SOLICITATION AMENDMENT MODIFICATION DE L'INVITATION

Title - Sujet CCGC Mechanical and Sprinklers	
Solicitation No. - N° de l'invitation EB144-190543/A	Amendment No. - N° modif. 008
Client Reference No. - N° de référence du client EB144-19-0543	Date 2018-08-14
GETS Reference No. - N° de référence de SEAG PW-\$PWA-121-5750	
File No. - N° de dossier PWA-8-80020 (121)	CCC No./N° CCC - FMS No./N° VME
Solicitation Closes - L'invitation prend fin at - à 02:00 PM on - le 2018-08-21	Time Zone Fuseau horaire Atlantic Daylight Saving Time ADT
F.O.B. - F.A.B. Plant-Usine: <input type="checkbox"/> Destination: <input checked="" type="checkbox"/> Other-Autre: <input type="checkbox"/>	
Address Enquiries to: - Adresser toutes questions à: Russell (PWA), Alex	Buyer Id - Id de l'acheteur pwa121
Telephone No. - N° de téléphone (902) 401-8180 ()	FAX No. - N° de FAX (902) 496-5016
Destination - of Goods, Services, and Construction: Destination - des biens, services et construction:

ADDENDUM NO. 2

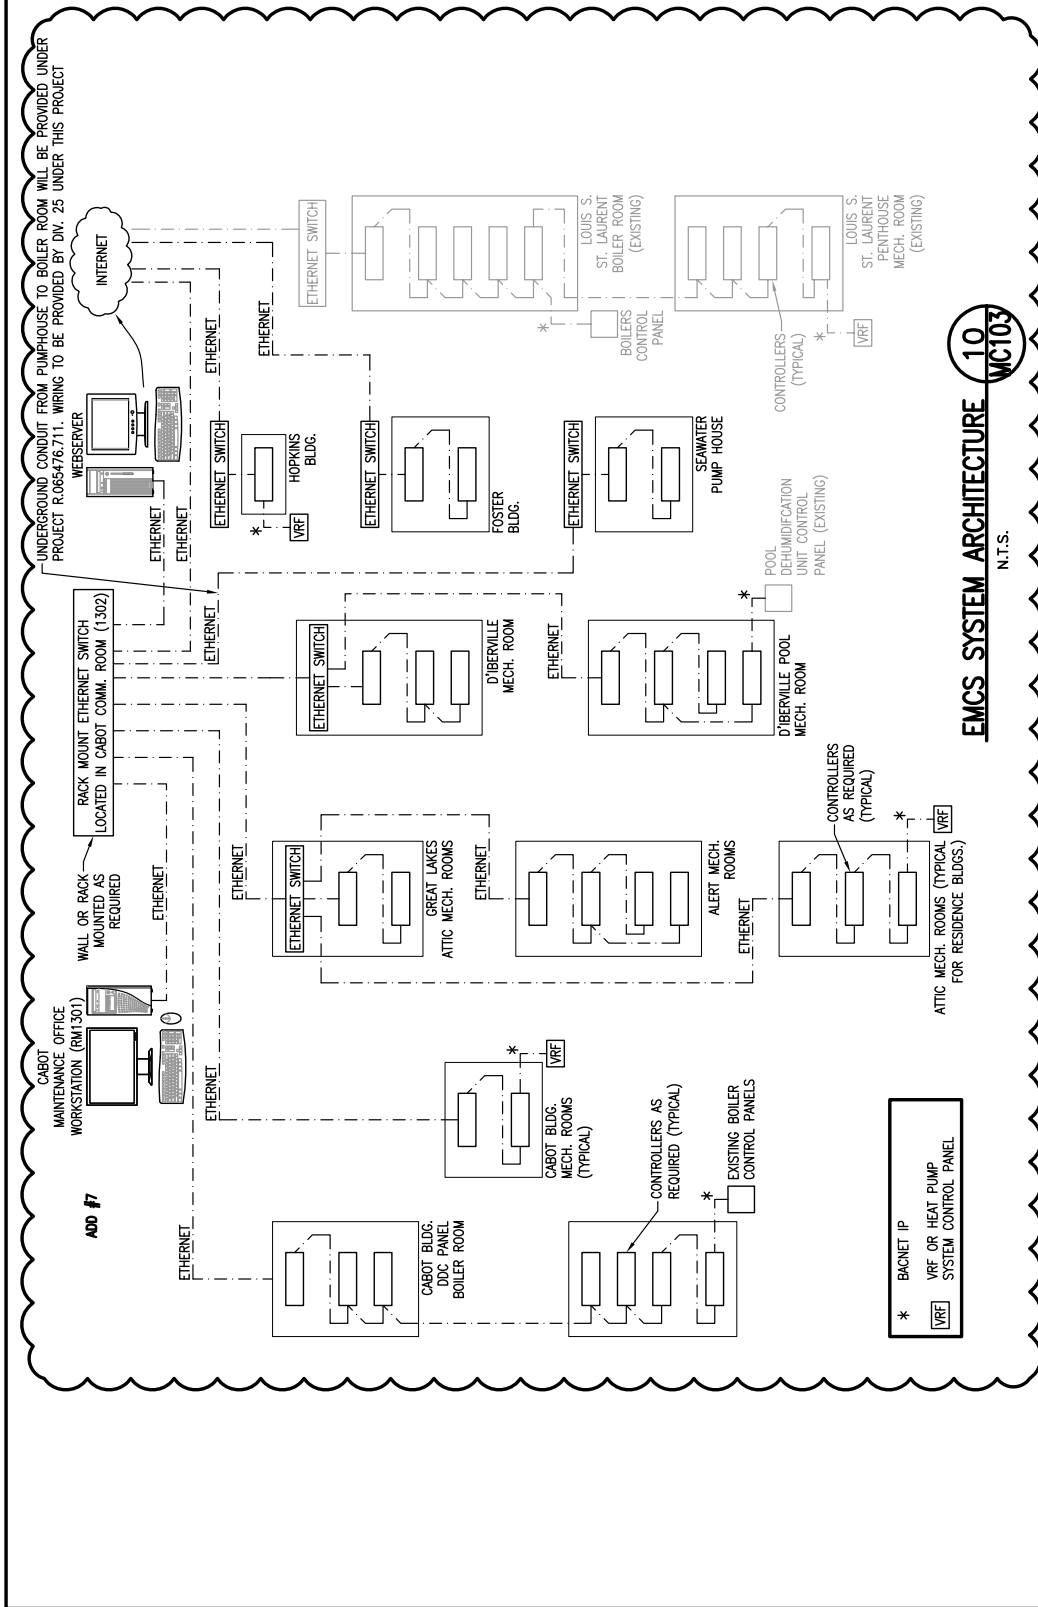
Item 3.2 DRAWING 01-MC-103 CONTROLS CABOT - SCHEMATICS

.1 Revise the drawing as per the attached Sketch 01-MC-SK001 (This Addendum).

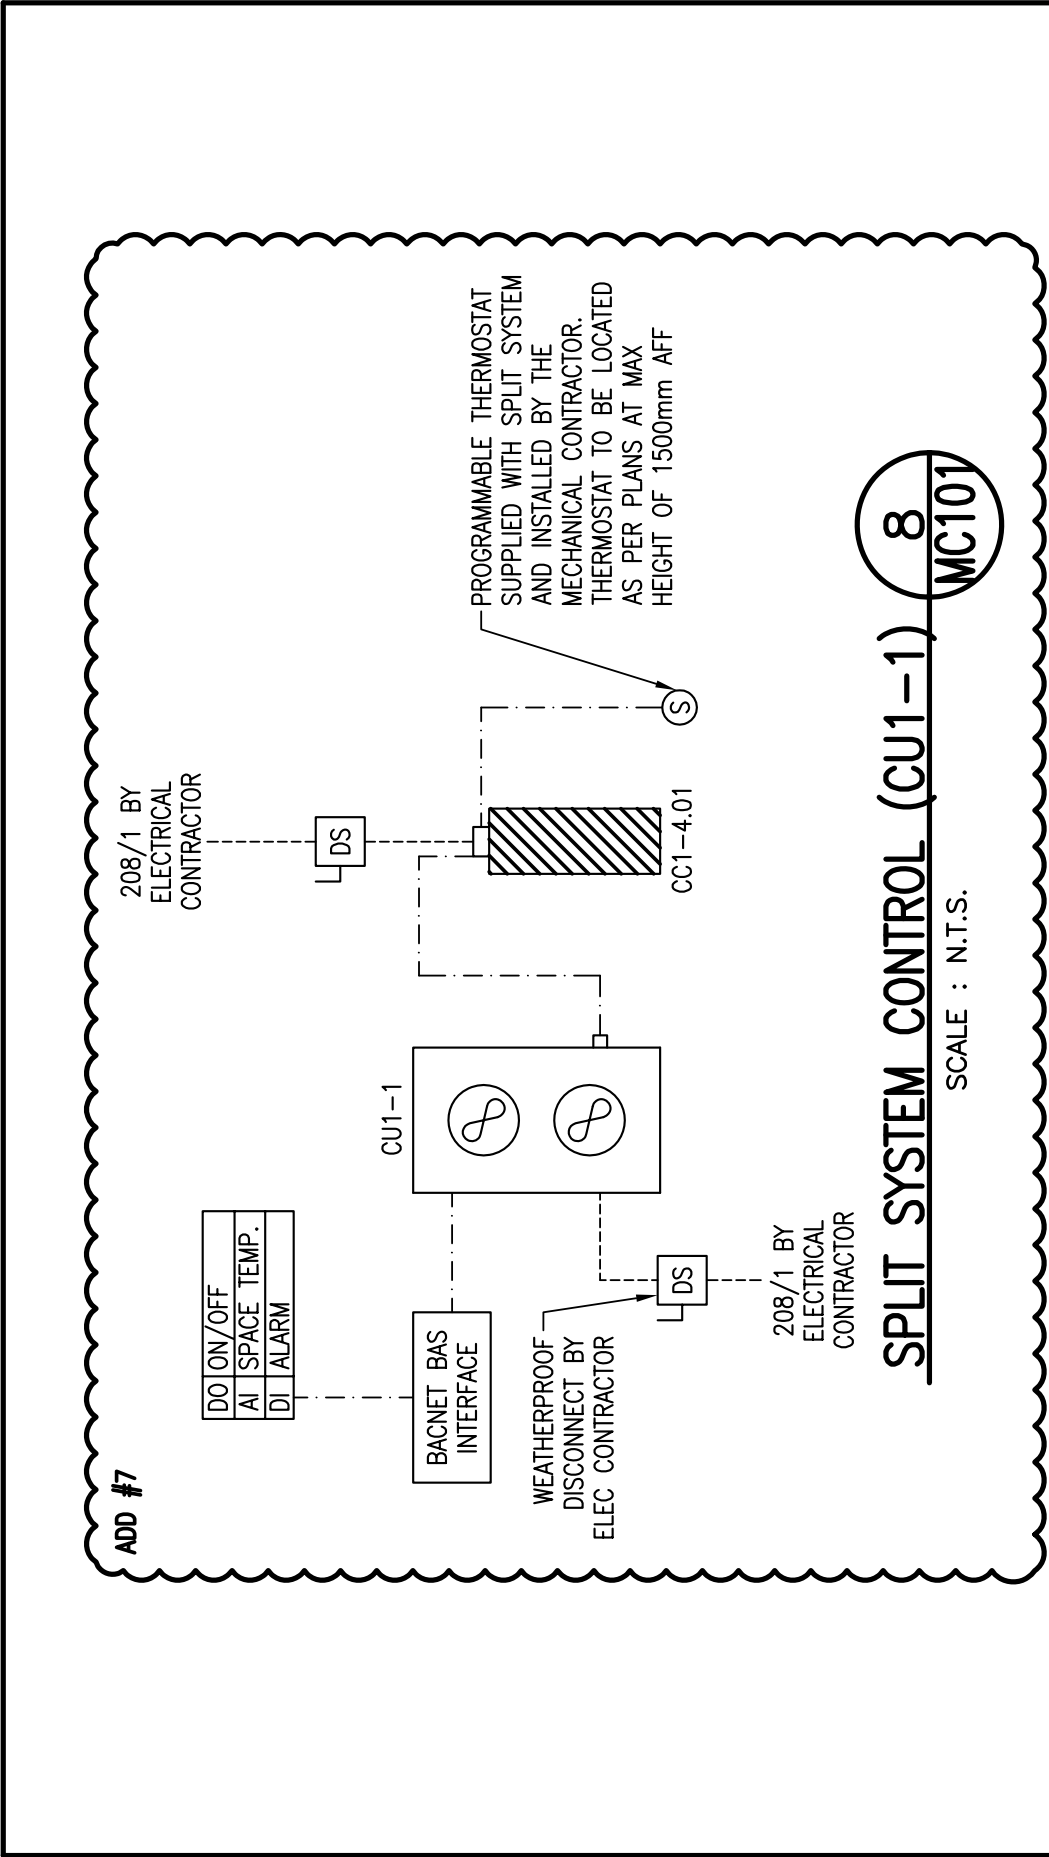
Item 3.1 DRAWING 01-MC-101 CONTROLS – CABOT - SCHEMATICS

.1 Revise the drawing as per the attached Sketch 01-MC-SK002 (This Addendum).

Reference Drawing: 01-MDP-107

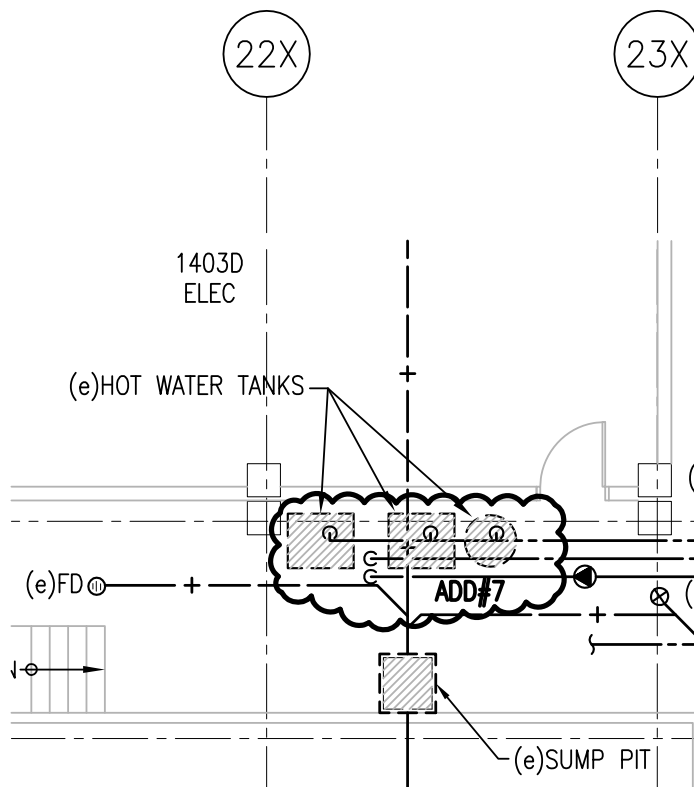
Item 3.12 DRAWING 01-MDP-107 PLUMBING - CABOT EAST - LEVEL 100 DEMOLITION

- .1 Revise the drawing as per the attached sketch 01-MDP-SK001.

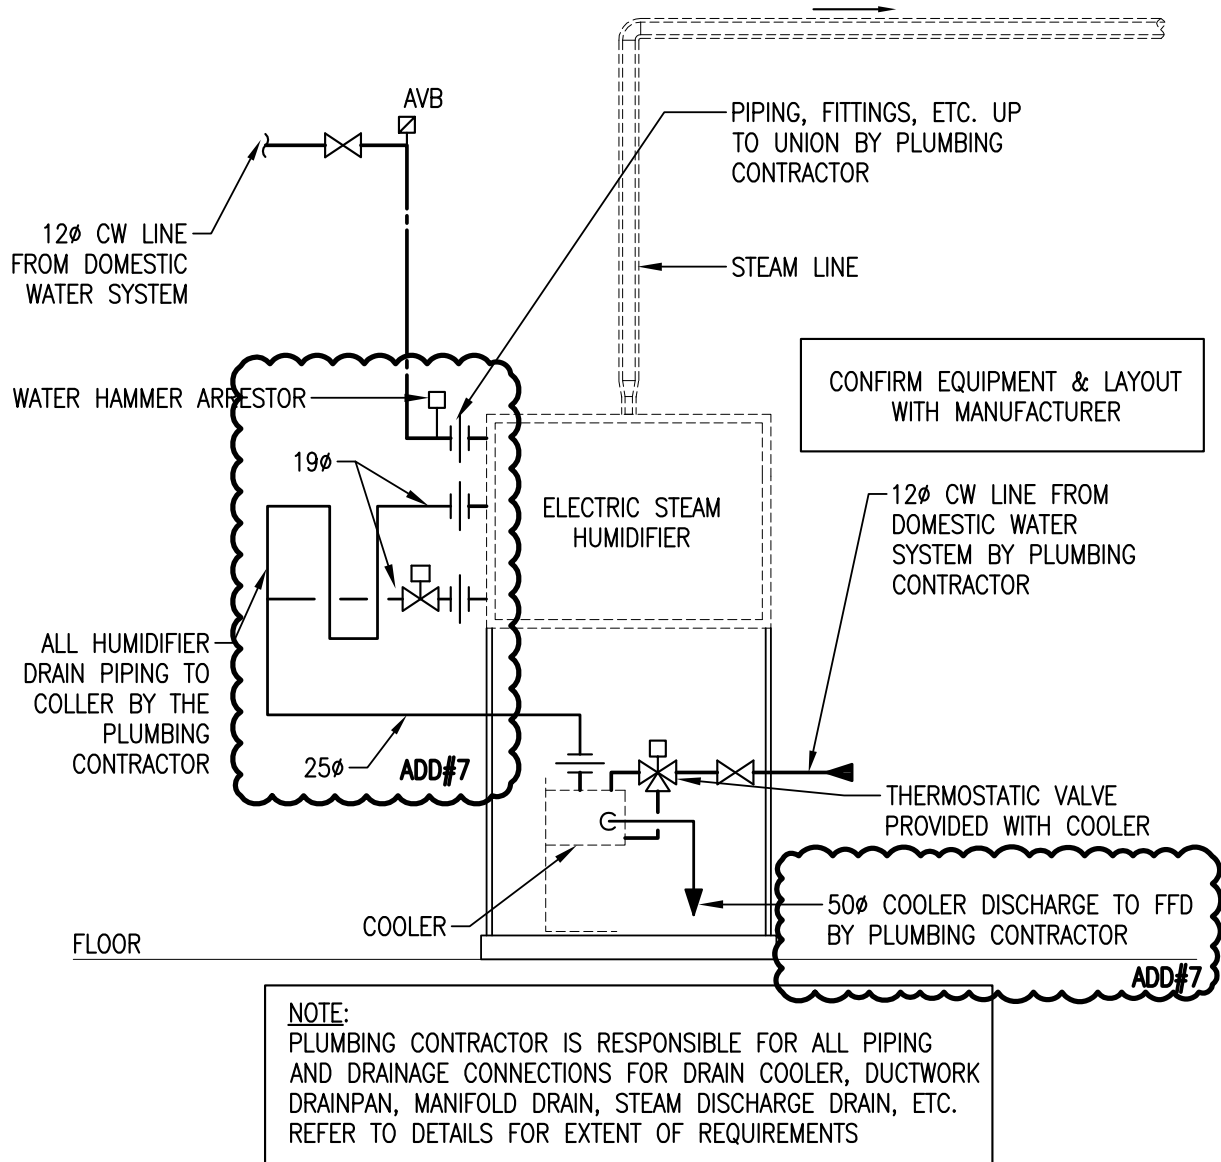
Item 3.18 DRAWING 01-MP-501 - CABOT - PLUMBING DETAILS

- .1 Revise pipe sizing on Detail 8 of this drawing per Sketch 01-MP-SK006 Pipe Sizing for Humidifier Piping Detail dated 2018-08-10 (This Addendum).

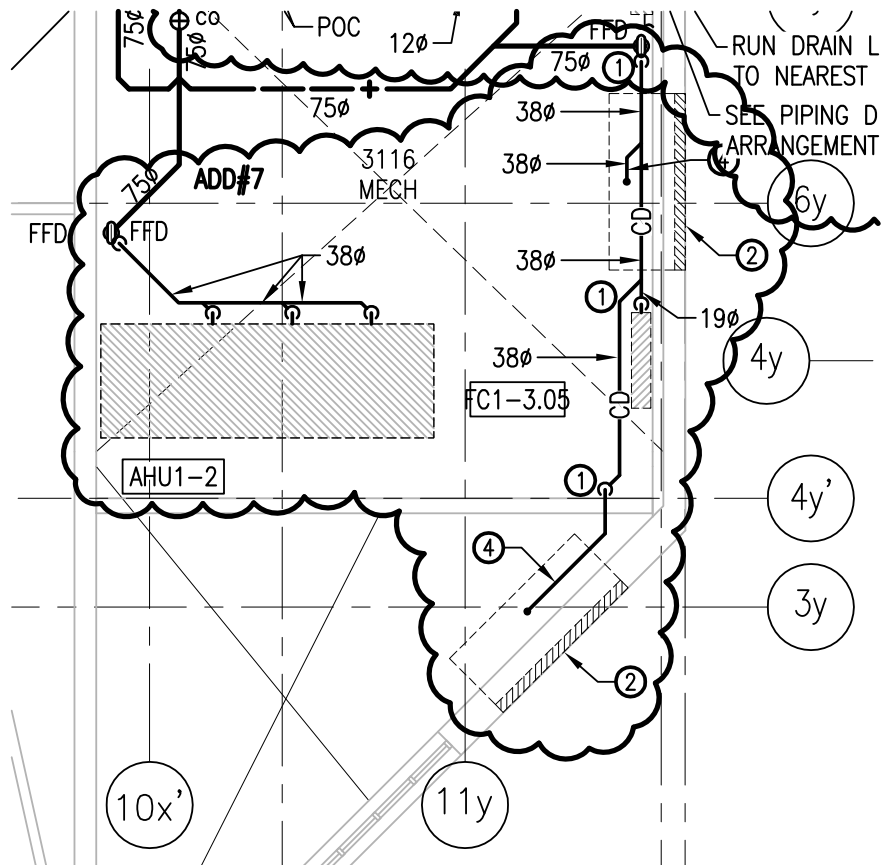
Item 3.14 DRAWING 01-MP-105 PLUMBING - CABOT CENTRAL - LEVEL 300 NEW WORK

- .1 Revise condensate pipe sizing from louvres and AHU1-2 in Mechanical Room 3116 per Sketch 08-MP-SK001 Cabot Level 300 Condensate Pipe Sizing dated 2018-08-10 (This Addendum).

CABOT FREEZER/ COOLER HEAT RECOVERY SCHEMATIC (1)
N.T.S.

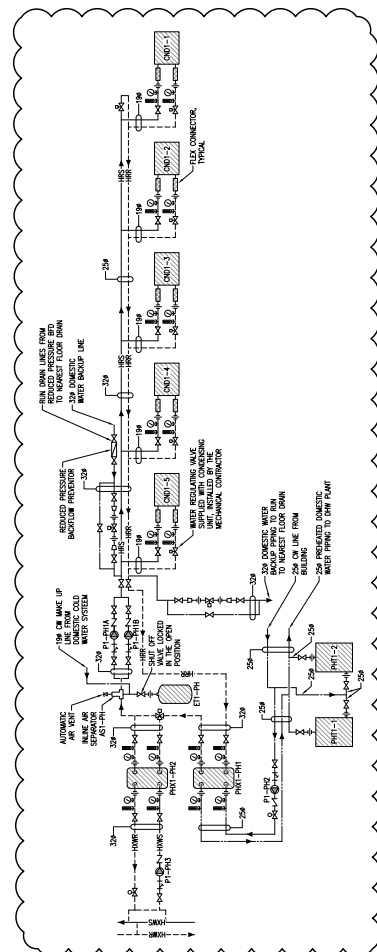
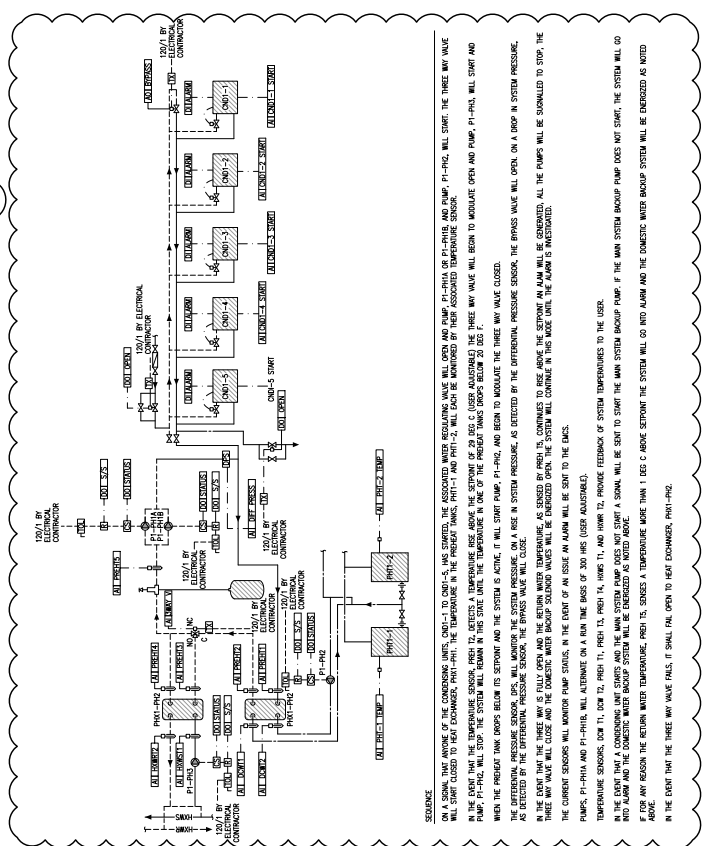
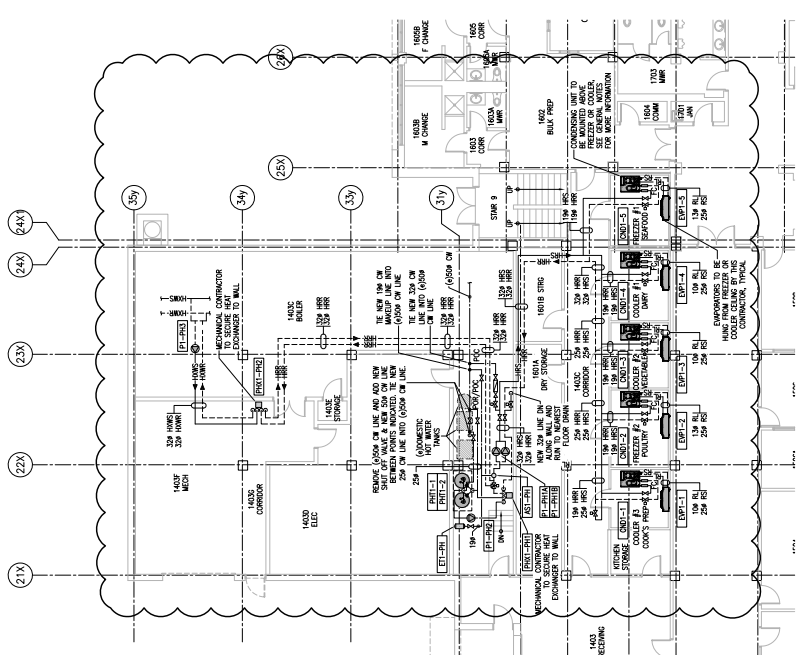
**Item 3.17 DRAWING 01-MP-401 PLUMBING - CABOT WEST -
FREEZER/COOLER HEAT RECOVERY LAYOUT & SCHEMATICS**

- .1 Revise freezer/cooler heat recovery plan and schematics per Sketch 01-MP-SK008 Plumbing Cabot West Level 100 Freezer/Cooler Heat Recovery Plan & Schematics dated 2018-08-10 (This Addendum).

Reference Drawing: 01-MV-110

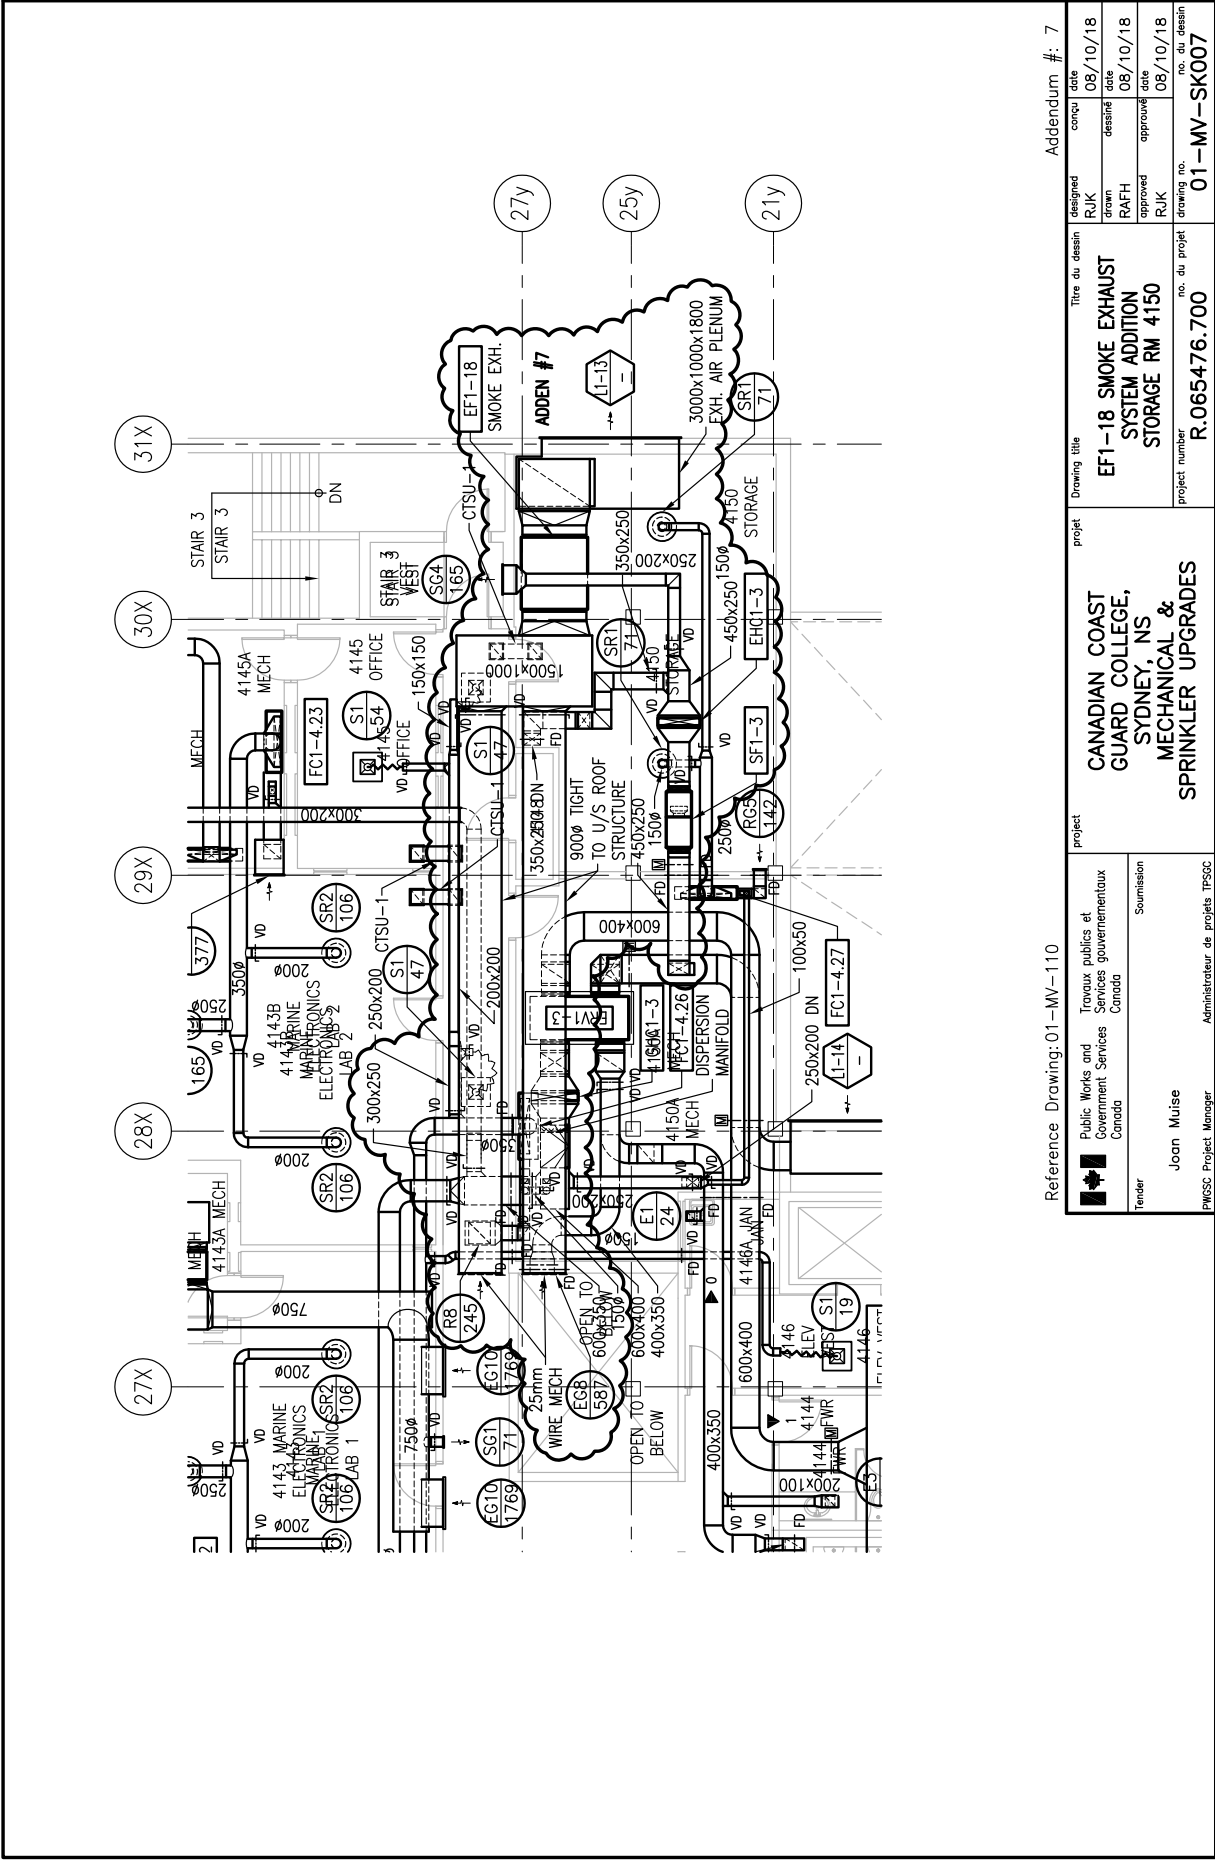
**Item 3.20 DRAWING 01-MV-110 - HVAC – VENTILATION CABOT EAST LEVEL
400 NEW WORK**

- .1 Add atrium Smoke Exhaust Fan System EF1-18 per sketch 01-MV-SK007 (This Addendum).

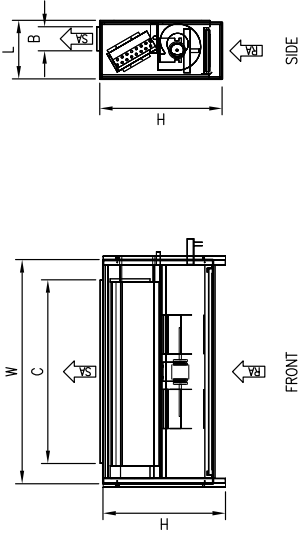
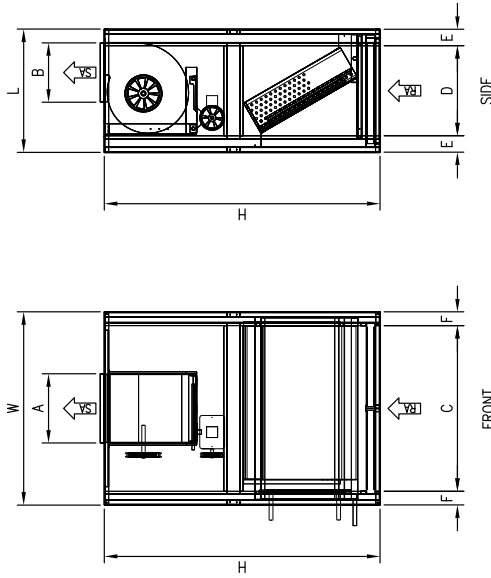
- .1 Add Detail 10 to this drawing per Sketch 01-MV-SK009 Vertical Ducted Fan Coil Detail dated 2018-08-10 (This Addendum).

- .1 Add Detail 8 to this drawing per Sketch 01-MV-SK009 Vertical Ducted Fan Coil Detail dated 2018-08-10 (This Addendum).

- .1 Add Detail 8 to this drawing per Sketch 01-MV-SK009 Vertical Ducted Fan Coil Detail dated 2018-08-10 (This Addendum).

- .1 Add Detail 8 to this drawing per Sketch 01-MV-SK009 Vertical Ducted Fan Coil Detail dated 2018-08-10 (This Addendum).

- .1 Add Detail 8 to this drawing per Sketch 01-MV-SK009 Vertical Ducted Fan Coil Detail dated 2018-08-10 (This Addendum).

- .1 Add Detail 10 to this drawing per Sketch 01-MV-SK009 Vertical Ducted Fan Coil Detail dated 2018-08-10 (This Addendum).

- .1 Add Detail 10 to this drawing per Sketch 01-MV-SK009 Vertical Ducted Fan Coil Detail dated 2018-08-10 (This Addendum).

- .1 Add Detail 4 to this drawing per Sketch 01-MV-SK009 Vertical Ducted Fan Coil Detail dated 2018-08-10 (This Addendum).
